CITY OF BOULDER
PLANNING BOARD AGENDA ITEM
MEETING DATE: Sept. 1, 2016

AGENDA TITLE: CONCEPT PLAN & REVIEW - Concept Plan Review and Comment for redevelopment of 1102 Pearl Street (currently the Old Chicago Restaurant) into a 15,380 square foot, three story retail office building of 38 feet. Reviewed under cas no. LUR2016-00058.

DATE OF COMMENTS: **August 12, 2016**
CASE MANAGER: **Elaine McLaughlin**
PROJECT NAME: **1102 Pearl Street**
LOCATION: **1102 PEARL ST**
COORDINATES: **N03W06**
REVIEW TYPE: **Concept Plan Review & Comment**
REVIEW NUMBER: **LUR2016-00058**
APPLICANT: **PHIL DAY**
DESCRIPTION: **Concept Plan Review and Comment for redevelopment of Old Chicago parcel into a 15,380 square foot, three story retail office building of 38 feet.**
REQUESTED VARIATIONS FROM THE LAND USE REGULATIONS:
Section 9-7-1: Two stories to three stories
Section 9-9-11: Open Space Reduction (land use intensity modification).

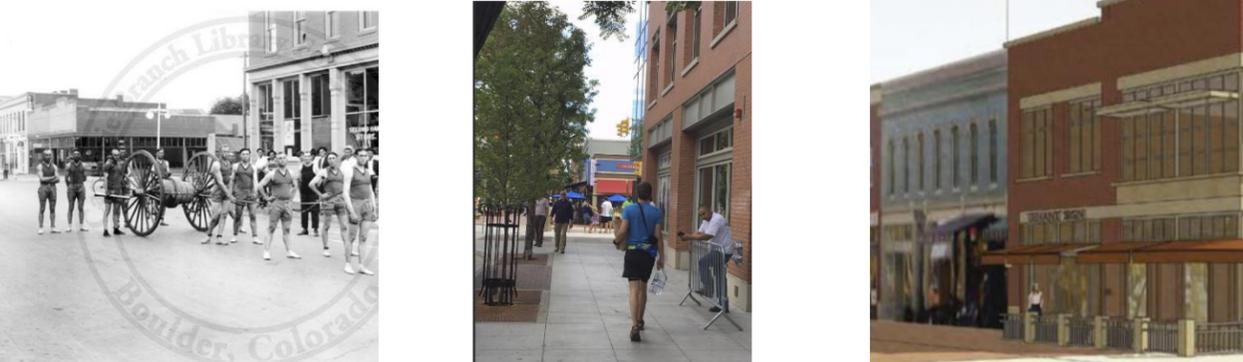
1.1 A.	The use of traditional durable materials as the primary building material is encouraged to reflect the historic building construction and development pattern within the district. Choose accent materials similar in texture and scale to others in the district	While the plans are conceptual in nature, the applicant appears to be proposing red brick with stone accents	preliminarily

1.1.B	Awnings may be used to provide visual depth and shade.	Awnings are shown.	Preliminarily	
1.1.C	Select building colors appropriate to area's historic character	While Red Brick appears to be a dominant material in the 1100 block of Pearl Street, not all buildings are red brick.; some historic buildings are a blond brick and some have had the brick painted over, including the adjacent building to the east of the site. However, the applicant is illustrating a red brick in keeping with much of the historic character of downtown Boulder which was established by the particular red clay soils of the region.	Preliminarily

1.1.D	Minimize the visibility of mechanical, structural, or electrical appurtenances	Not currently illustrated, applicant should consider low profile mechanical or embedding mechanical into building	unknown	-----

1.1.E	Improve rear or side alley elevations to enhance public access from parking lots and alleys	The conceptual sketch of the alley elevation does appear to address enhancements, however, the applicant should consider display windows and secondary customer alley access	partially

GUIDELINES:	ANALYSIS:	CONFORMS	
1.1.F.	<i>Exterior building lighting should be designed to enhance the overall architecture of the building.</i>	This guideline should be considered at site review.	Unknown at this time	-----
1.1.G	<i>Reduce the visual impact of structured and surface parking</i>	A planter is shown against a screen wall adjacent to 11 th Street. The applicant may want to consider a more robust means of screening alley parking in this location.	partially	 <p>Parking Screening Proposed</p>
1.1.H	<i>The law requires that universal access be located with the principal public entrance</i>	Applicant appears to have addressed this.	yes	-----

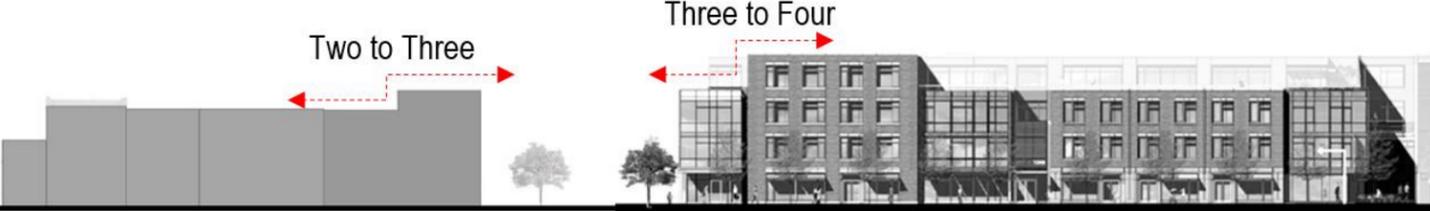
1.3.A	<p>Incorporate traditional building elements in new design and construction. Please see Section 1.1 for a list of historic buidling elements:</p> <p>(1.2.A):</p> <ol style="list-style-type: none"> 1. Full-dimension bricks, or stone 2. Display window bulkheads 3. Large storefront display windows 4. Recessed and corner entrances 5. Secondary entrances and detailing 6. Storefront transom 7. Sign bands and storefront cornice 8. Parapet walls, caps, and/or roof cornices 9. Upper story vertically proportioned windows and/or fenestrations 10. Columns, pilasters, and piers 11. Decorative window sills, lintels, window hoods, and other window assembly elements 12. 25' Historic Bay 	<p>The proposed concept plan, while early in the design process does illustrate elements that appear to be consistent with the traditional elements listed.</p> <p>One exception to this is that the corner of Pearl and 11th has retractable windows. This treatment wouldn't be considered consistent with the traditional elements of the downtown.</p> <p>Similarly, the very tall "freeboard" and parapet walls are not traditionally scaled or proportional to the buildings. The tall parapet creates an appearance of a much taller building for the two story portion than would be proportional for a two story building.</p> <p>The paired windows shown on the second story of 11th Street are more in keeping with the traditionally vertically proportioned windows. The window openings on Pearl are more square than vertical</p>	partially	 <p style="text-align: right; font-size: small;">VIEW FROM NO</p>

GUIDELINES:	ANALYSIS:	CONFORMS	IMAGES
1.3.B	<p>Construct new buildings to maintain the continuity of the historic building relationship to the street, adjacent properties, and/or the block.</p>	<p>The building is shown to maintain the historic relationship of a zero lot line along both Pearl and 11th streets.</p> <p>With the former Daily Camera site returned to its original urban configuration along the street, the new building will retain the urban configuration as shown.</p>	yes

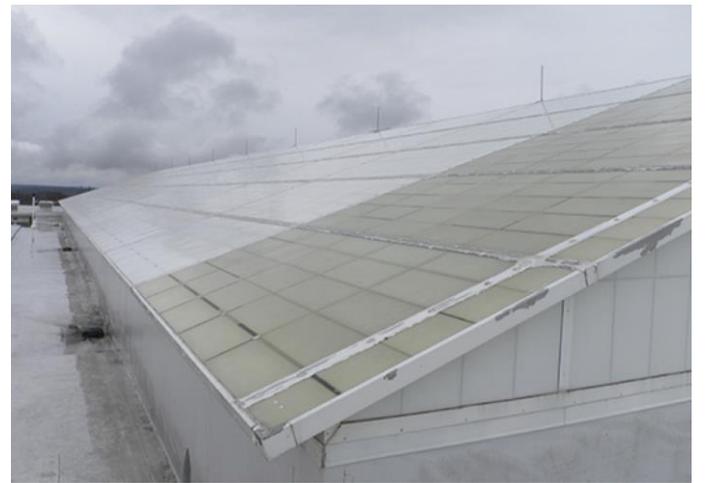
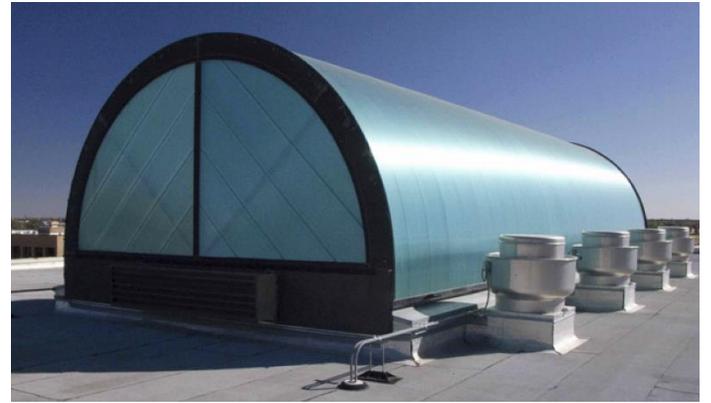
1. Lightwell to bring light to our offices (you could request a variance and add the lost GLA at the top floor of your building)
2. Make the exit stair in the back an open stair like the one in the photos attached. This will help us conserve more views and light from the corner of our office.
